Improvements for Heavy-Duty Engine and Vehicle Test Procedures, and other Technical Amendments

Response to Comments

Assessment and Standards Division
Office of Transportation and Air Quality
U.S. Environmental Protection Agency

Figure 2: Input Torque Range: Transient Cycle, Nominal Vocational Truck
12-Speed Endurant AMT

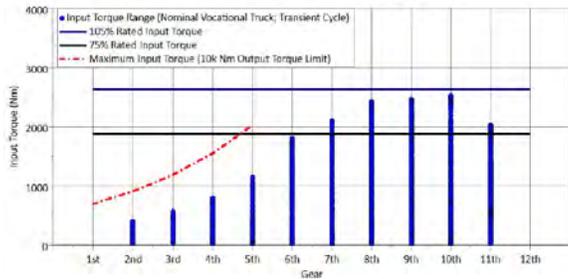
The dashed curve represents the max input torque measurement curve to show where our lab is capable of measuring, relative to the max input torque seen throughout the transient cycle. In this case, GEM would not be required to perform any extrapolation if the lower range was certified at part-load, as all input torque points would be captured by the measurement points.

In February of 2020, the ECJV submitted a request for a Special Test Procedure to permit part-load measurement where output torque is a concern. The EPA has approved this request with the provision that the total GEM extrapolation time of gears measured at part-load cannot exceed 10% for any given cycle.

We agree with the comment that, as currently written, the language in §1037.565(d)(2) makes it prohibitive to certify lower gears (high numerical ratio) where the output torque produced at the transmission’s rated input torque may exceed the capability of the test cell. Based on consideration of this and EPA’s previous granting of a request for a Special Test Procedure to permit part-load measurement where output torque is a concern, we are finalizing a change to 40 CFR 1037.565(d)(2) to address this in the regulation.

The modification to 40 CFR 1037.565(d)(2) optionally allows that in higher gear ratios where output torque may exceed dynamometer torque limits, you may use good engineering judgment to measure loaded test points at lower input torque values. In this case GEM may need to extrapolate values outside of the measured map. Extrapolation time may not exceed 10% for any given cycle and you must describe in the application for certification on how you measured these loaded test point at lower input torque values.

Figure 4: Percentage of Overall Cycle Points Extrapolated Relative to Axle Ratio

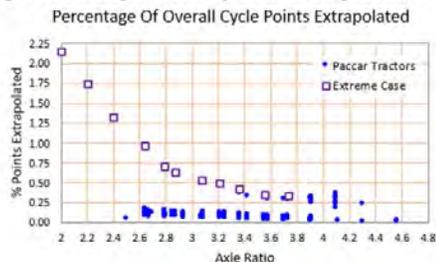
In addition to analysis of production intent applications, worst-case configurations were also evaluated. In this case a down-spud, inefficient tractor (non-production) showed less than 2.25% extrapolation across all cycles, and less than 7% extrapolation in the transient cycle. It was found that axle ratio had the greatest impact on the amount of extrapolation required. See Figure 4 below:

Given the information above, the ECJV would respectively like to request a more permanent solution by proposing an amendment to the language: “(2) Include one loaded torque setpoint between 75 % and 105 % of the maximum

Figure 1: Engine contributions to overall vehicle efficiency improvements in the current Phase 2 regulation and assuming a 2 percentage point loss in engine CO₂ reductions

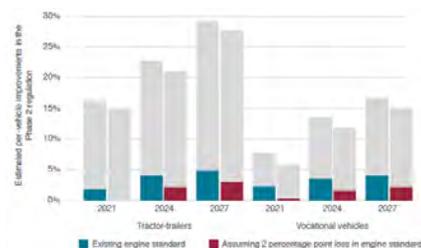
Figure 1 puts the Phase 2 engine improvements in 2021, 2024, and 2027 in the context of the overall requirements for tractor-trailers and vocational vehicles. The blue portion of each bar chart represents the estimated contribution of the engine to total efficiency improvements in the existing regulation. The red portions of the righthand bar charts show the reductions resulting from the proposed interim provisions, assuming a 2 percentage point increase in engine CO₂ levels. Figure 2 shows the estimated reduction in overall stringency from a 2 percentage point loss in engine efficiency. As shown, on a per-vehicle basis, the proposal represents losses at the vehicle level of up to 5% to 9% for tractor-trailers and 10% to 25% for vocational vehicles. Finally, extending these per-vehicle impacts to the entire fleet of HDVs impacted under the Phase 2 regulation, the potential losses in terms of cumulative CO₂ emissions are summarized in Figure 3. By 2030, we estimate that the proposed interim provisions could result in up to roughly 60 million metric tons (MMT) of cumulative additional CO₂ emissions, which is a 12% loss versus the current regulation. By 2040 and 2050, increased cumulative emissions grow to nearly 190 MMT (9% increase) and 340 MMT (8% increase), respectively.

We received comment on this issue from CARB, EMA, ICCT, ACEEE, and NACAA as noted above. After considering the comments received, we are adopting the limited transitional approach aimed at addressing the manufacturers' variability concerns, please see Section II.B.3. of the preamble that clarifies our intent for this interim provision. With regard to making it clear that the interim confirmatory testing provisions apply to powertrain testing, we intended our proposal for these provisions to include powertrains and agree that it is appropriate to do so, as the current and proposed 40 CFR 1036.235(c) clearly provides that confirmatory testing applies to powertrains. The revisions to the regulations we are finalizing accordingly include additional clarifying changes to 40 CFR 1036.150(q) and 1036.235(c)(5) to further specify that these interim confirmatory testing provisions apply to powertrains as well.

Figure 3: Potential impacts to cumulative CO₂ emission reductions

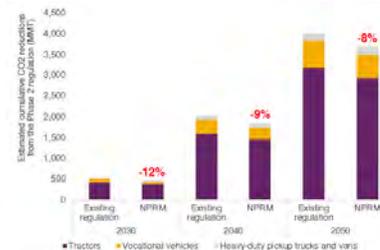
The interim provisions could lead to a significant erosion in stringency in the Phase 2 standards. The tables and figures below provide some analysis to illustrate why these proposed interim provisions could potentially erode the required efficiency improvements from tractor trucks and vocational vehicles and lead to a sizeable loss in emissions benefits over time.
